ARVIDA CORPORATION
 HARBOURSIDE DRIVE and FAIR OAKS LANE
 TREE PRESERVATION AND RELOCATION DRAWING

DWG. No. 191-730

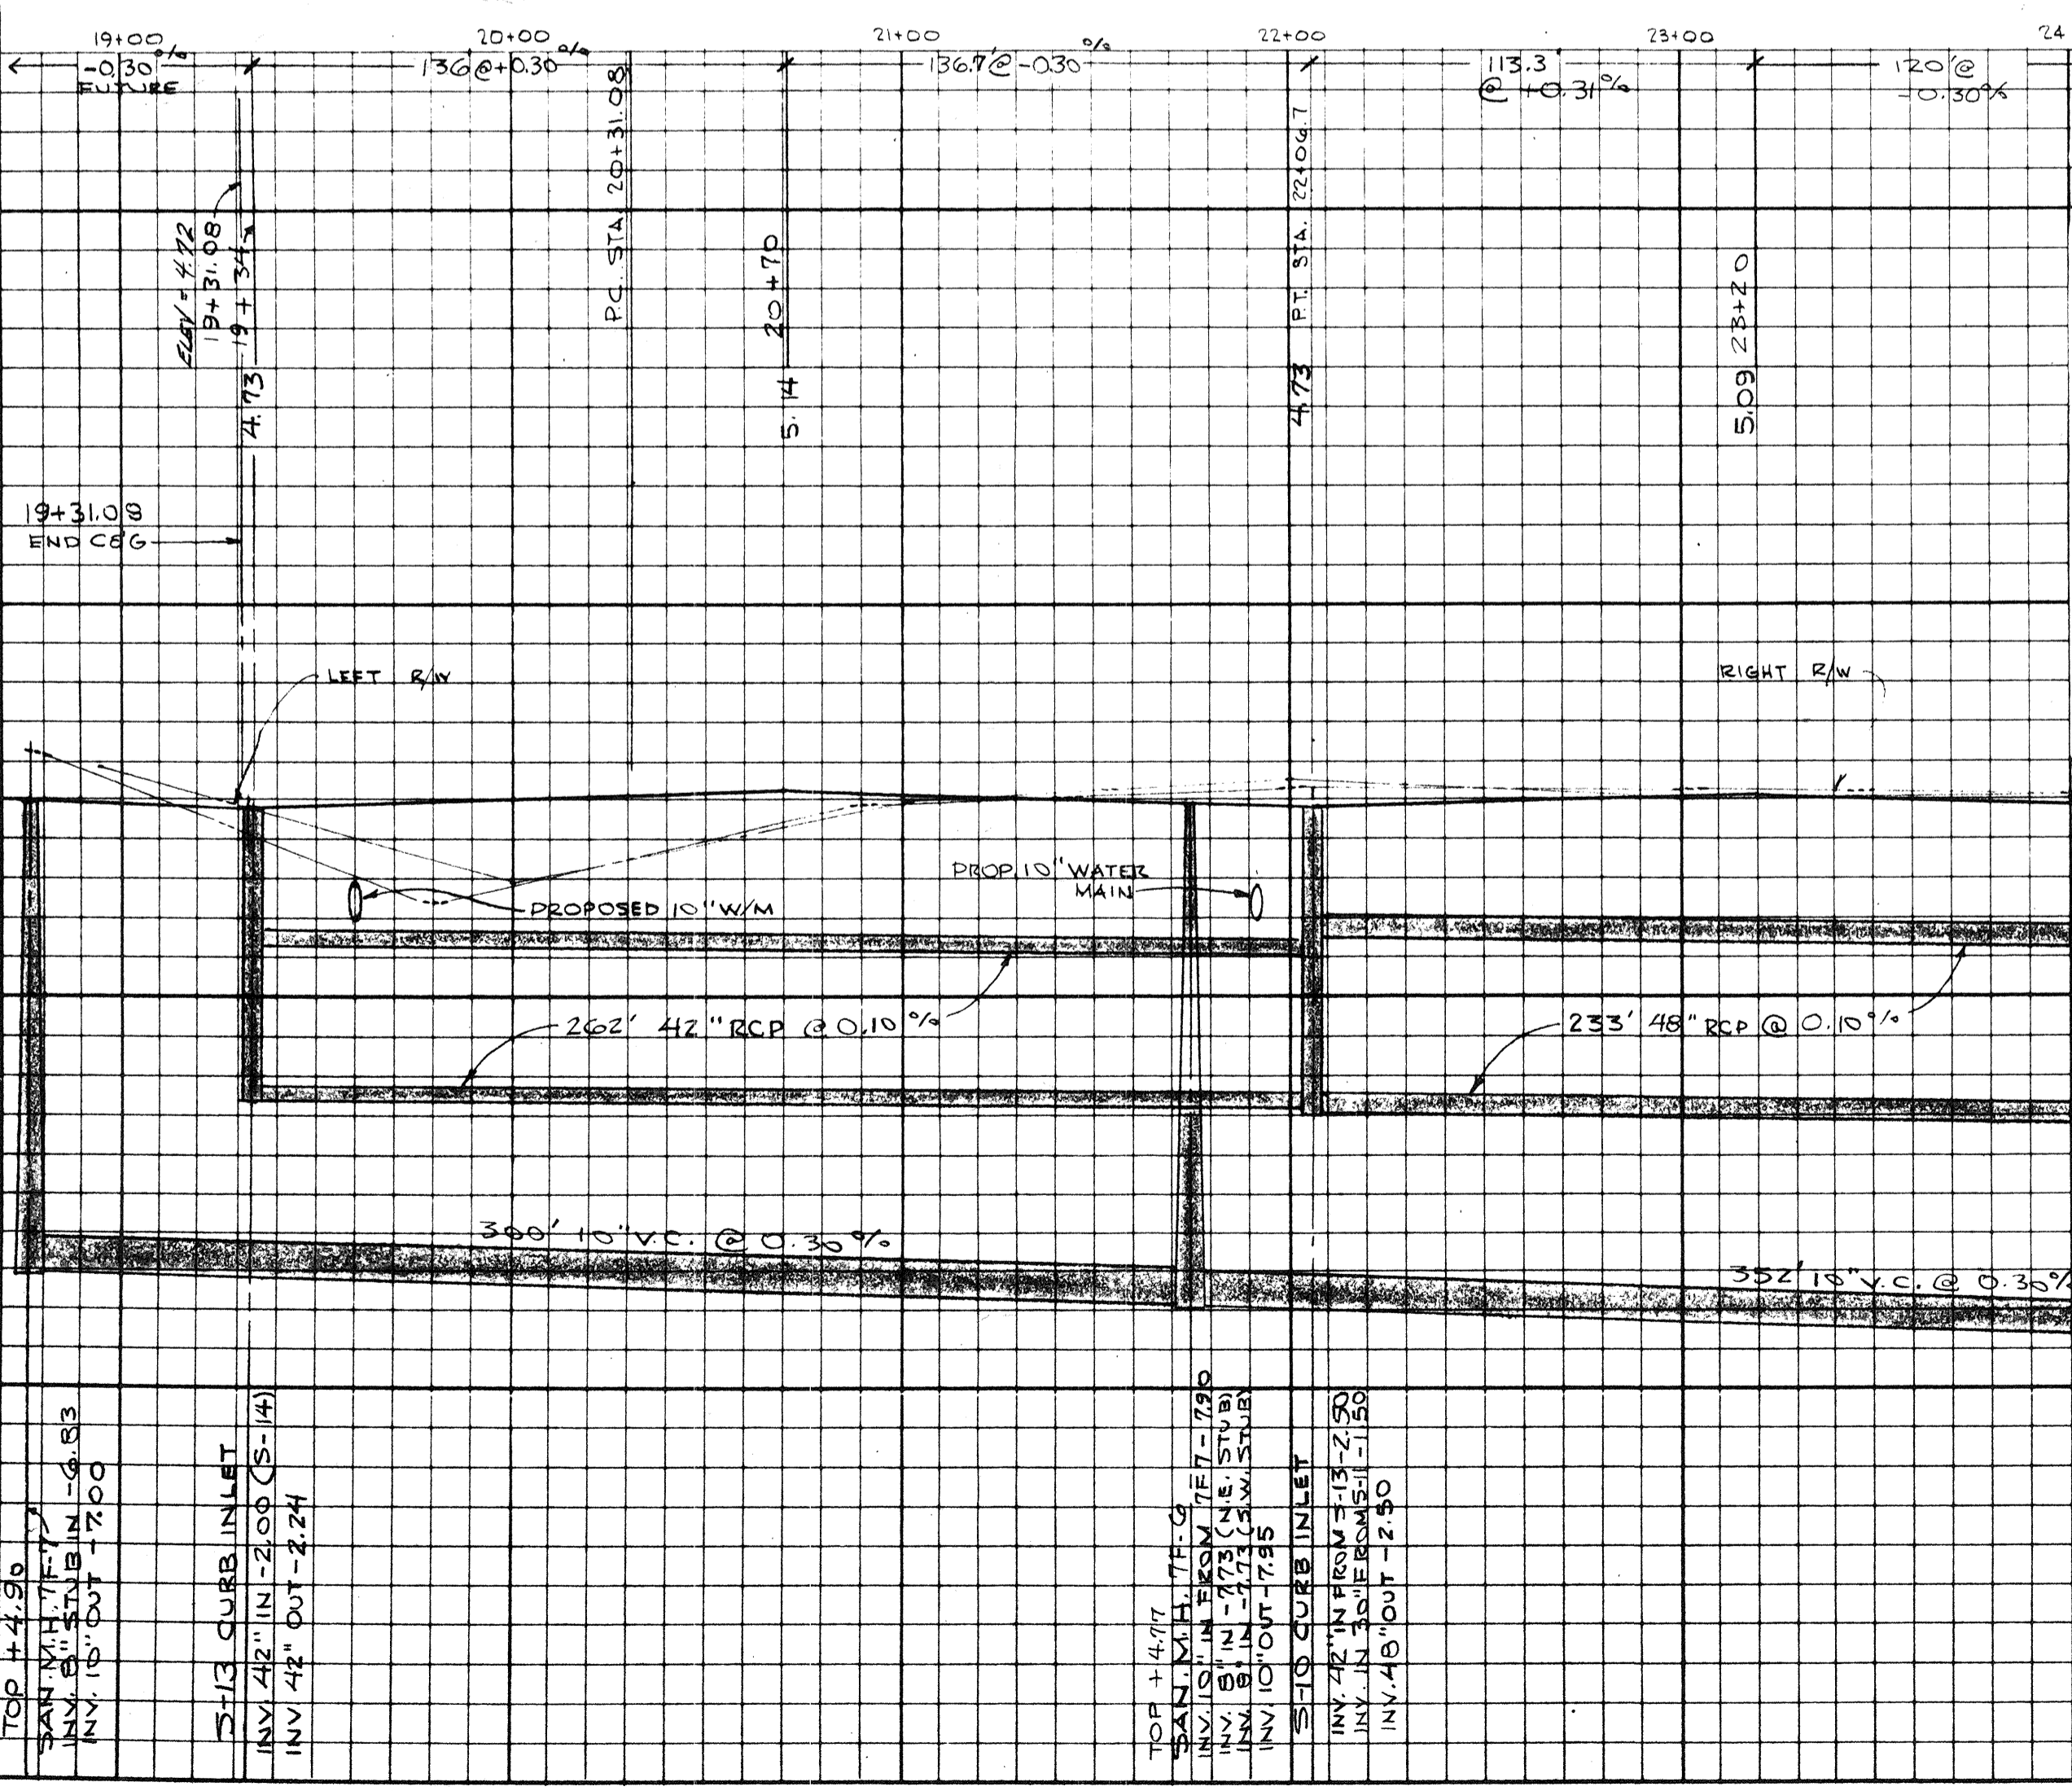
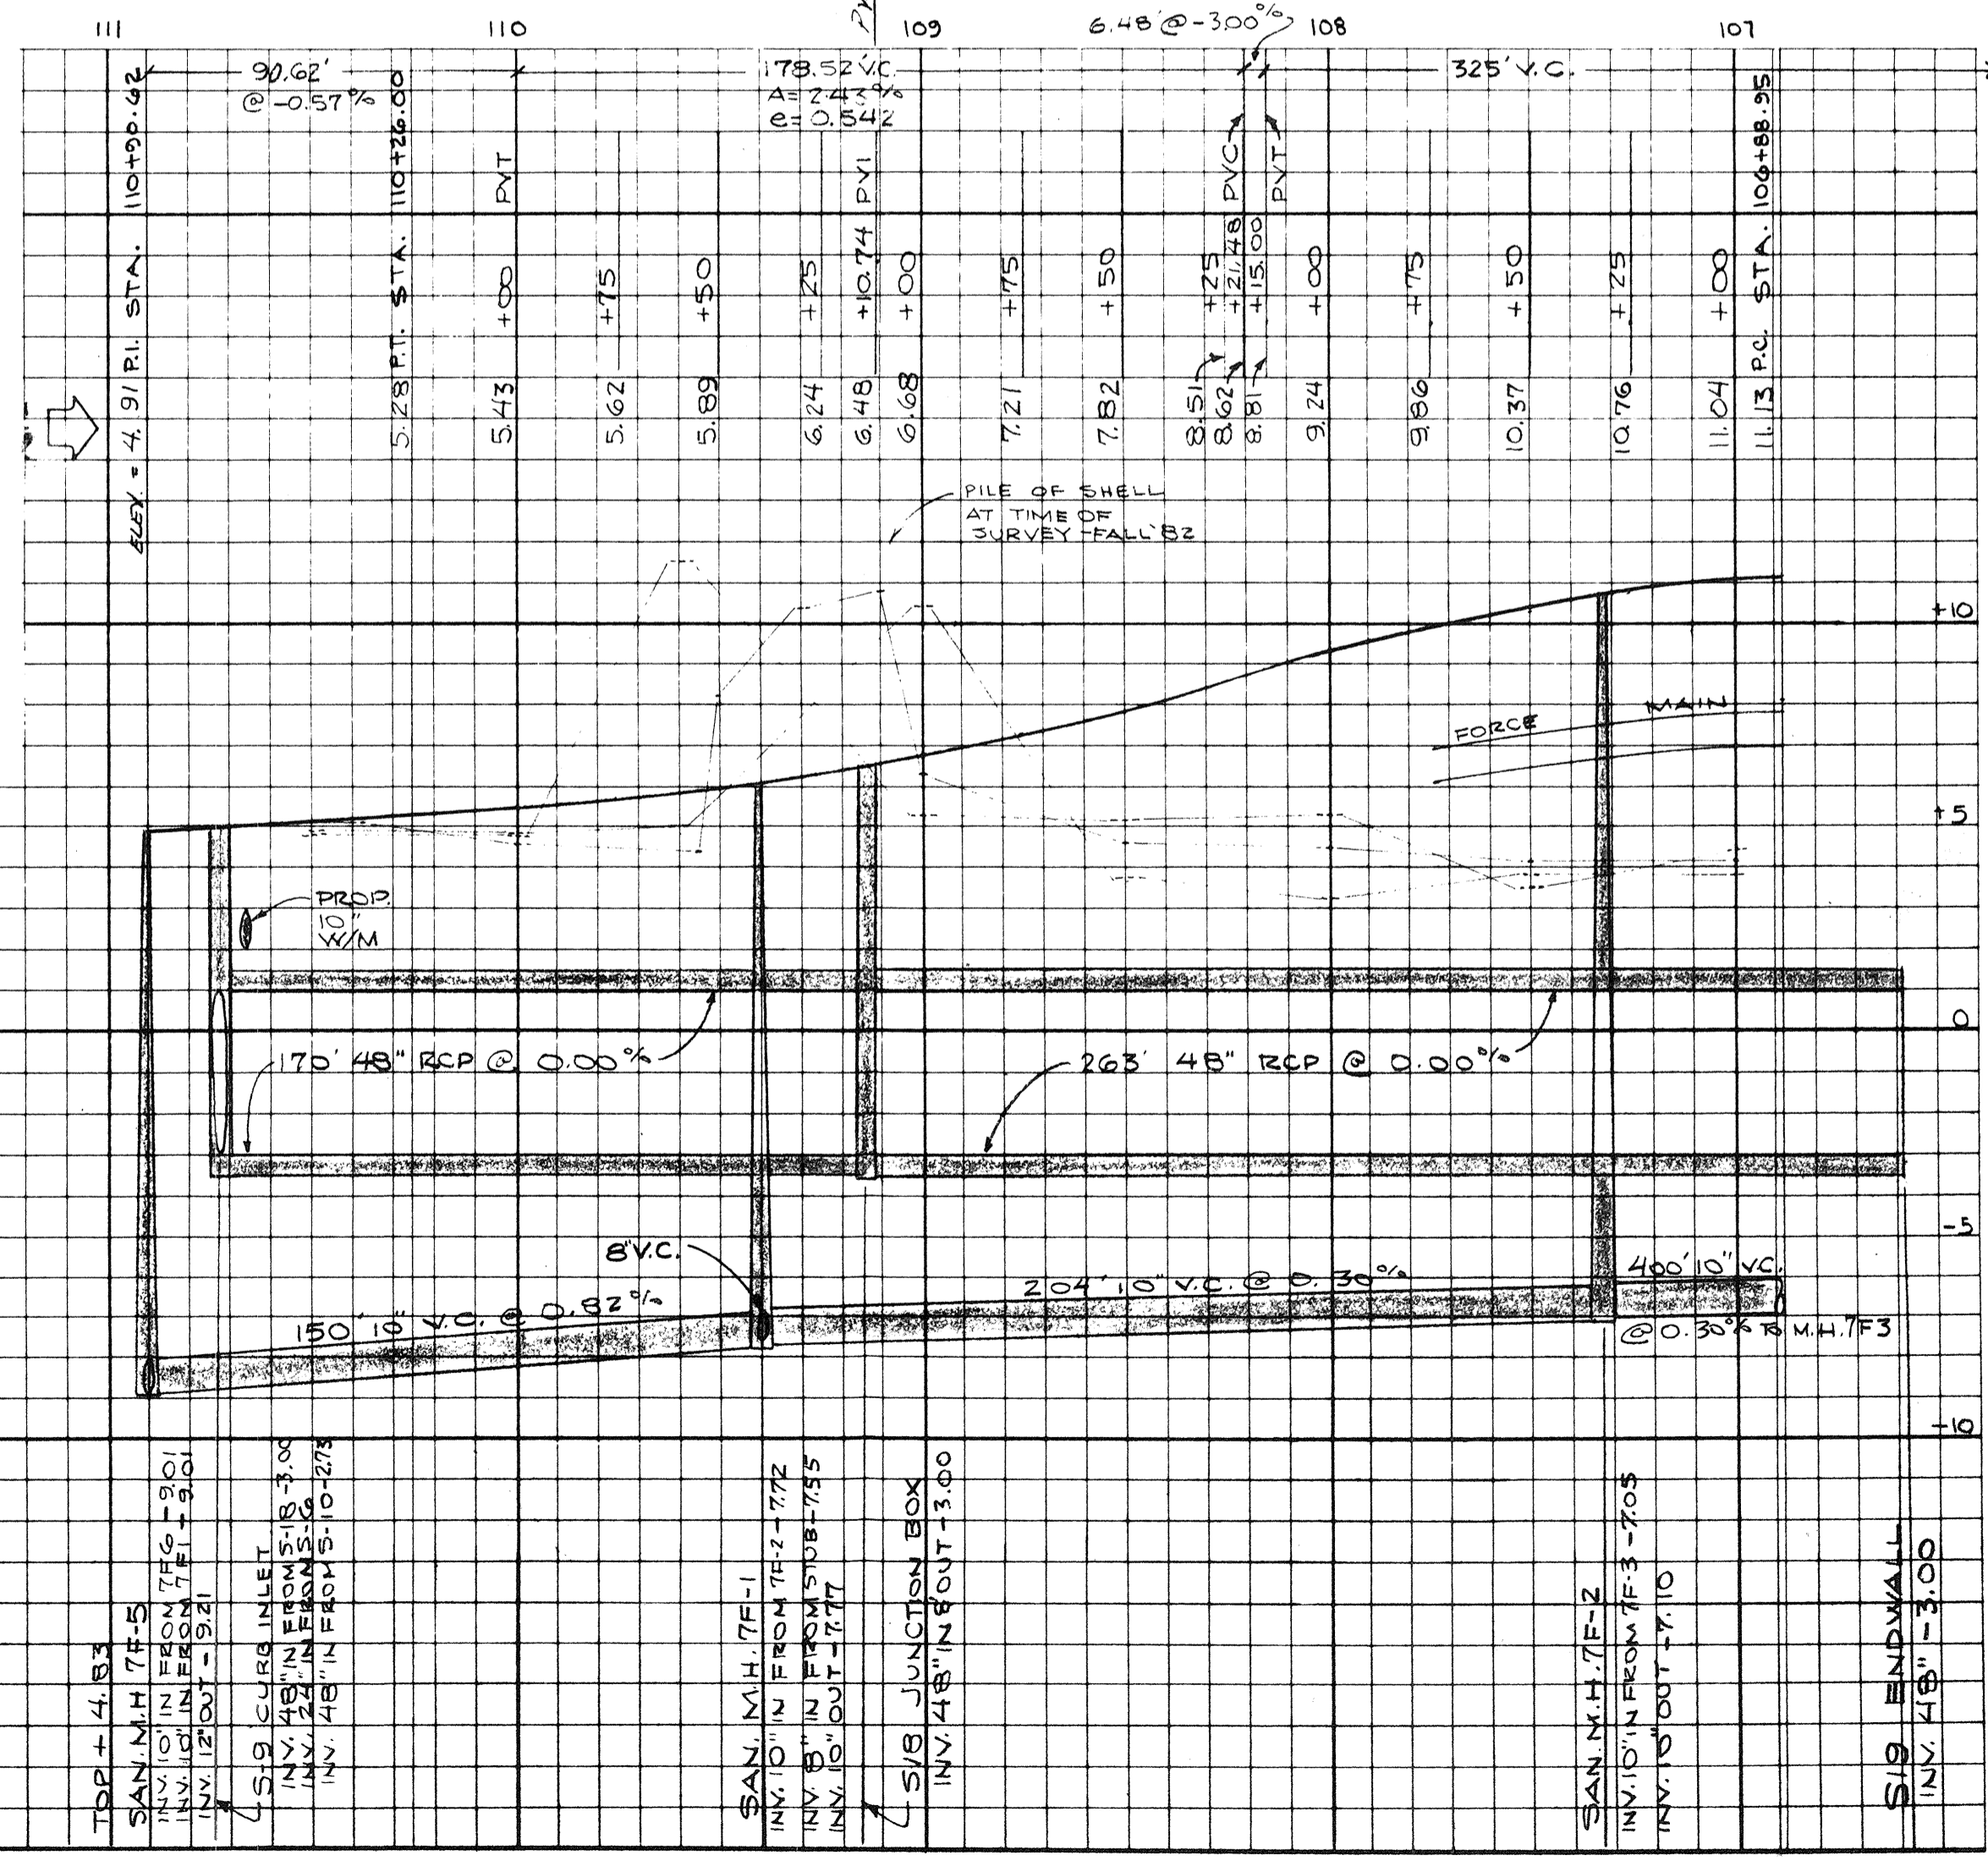
* TREES TO BE REMOVED
 ADDED TO THIS DRWG. ON 3-31-83
 TABULATION OF ADDED TREES
 5 OAKS
 3 PINE

TREES TO BE TRANSPLANTED		AMENDMENT 3-31-83	
Species	No.		
Palm	3	>	11
TREES TO BE REMOVED			
Species	No.		
Pine	11	>	10
Oak	0	>	10
Cedar	0		
Fig	0		
TREES WITHIN SAVE AREA			
Species	No.		
Oak	0		
Palm	0		
Pine	0		
Fig	0
